Comments on Mobility Modeling in Draft IEEE 802.16m Evaluation Methodology Document (Section 9.1)

Rob Nikides and Fan Wang
Motorola

Figure 1. - 19 cell abbreviated example of MS movement in a wrap around environment. Blue lines denote paired wrap around boundary segment.

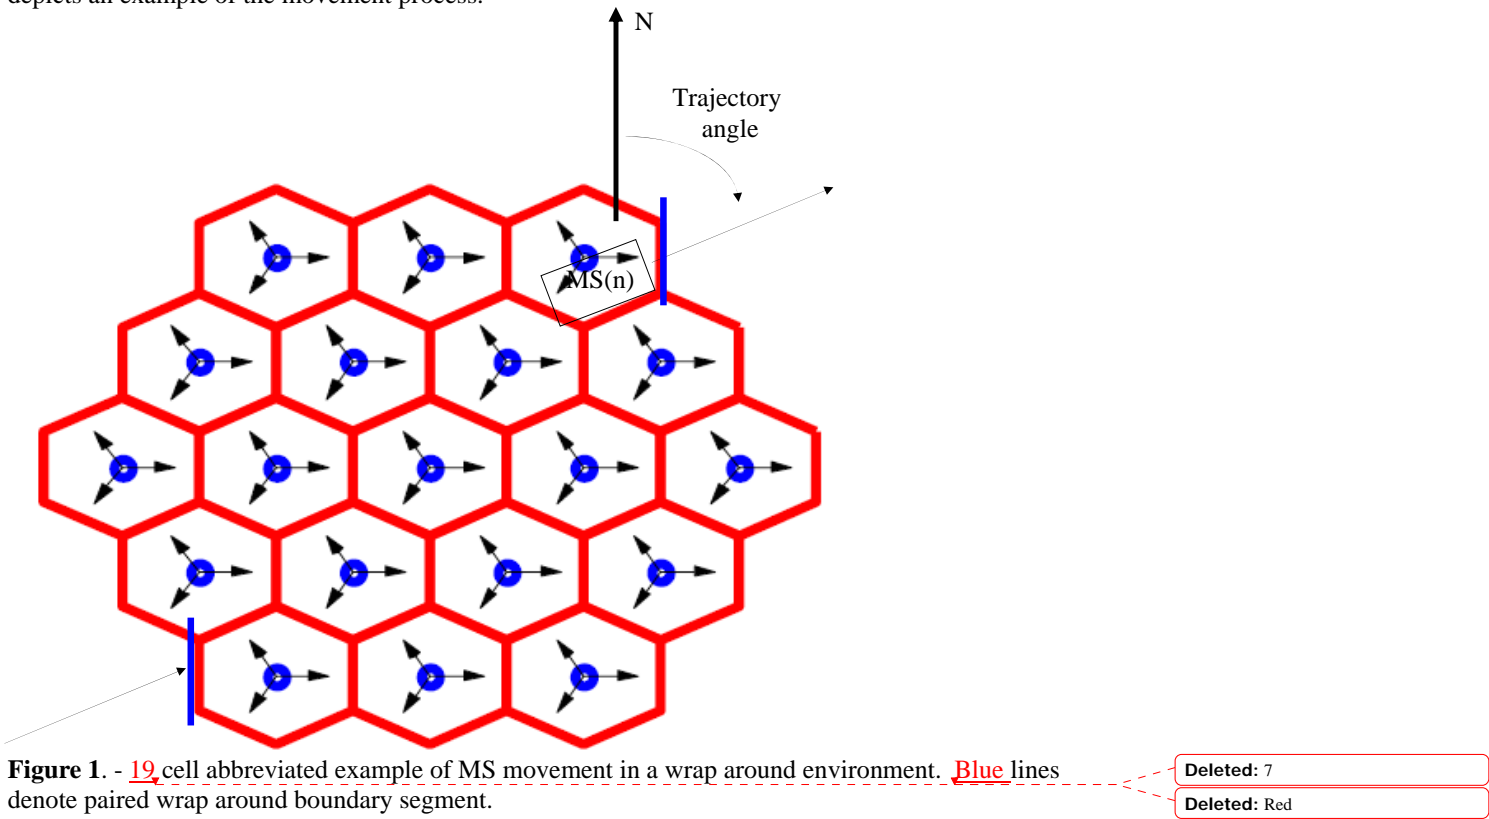
A dropped MS is assigned an angle of trajectory at the beginning of a call. The assigned angle is picked from a uniform distribution across the range of 0-359 degrees in one degree increments. The angle of zero degrees points directly North in the simulation environment.

Movement of the MS is established by selecting a random speed for the users according to profiles in section 4.3.1 such that the population of MS users meets the desired percentages. The MS remains at the selected random speed and direction for the duration of the simulation drop. When a MS crosses a wrap around boundary point within the simulation space, the MS will wrap around to the associated segment identified within Appendix G, continuing to keep the same speed and trajectory. Figure 1 depicts an example of the movement process.

Figure 2 – Simplified representation of plane based approach to RF environment modeling

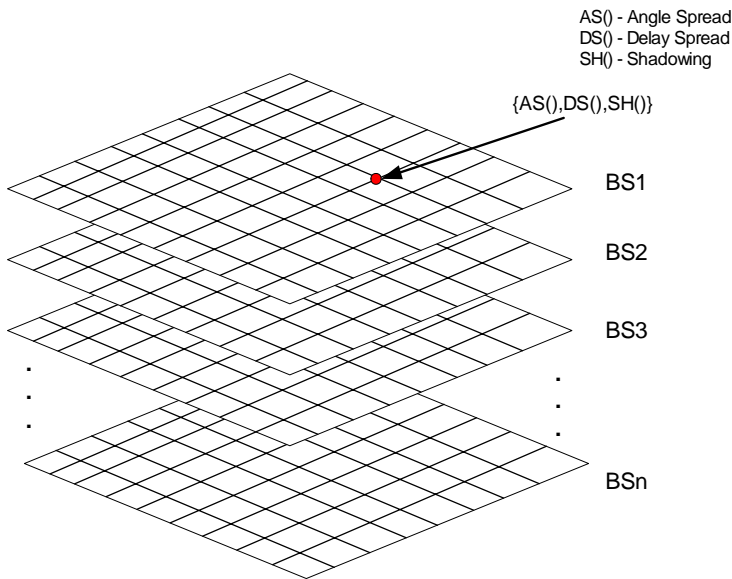
The second part of this proposal is to generate an RF model that reflects the transitional behavior of a real system, including de-correlation distance and the already modeled site to site correlations. One method to accomplish this is through a set of planes, with each plane representing the environment of a given site and/or sector over the simulation space. The planes are divided up in a uniformly spaced grid, using the de-correlation distance to define the desired spacing of sample points. Each point on the grid represents a triplet of angle spread, delay spread, and shadowing parameters. MS locations between the grid points are interpolated. The shadow values are then applied over the defined pathloss models. A visual representation of the model appears in figure 2.
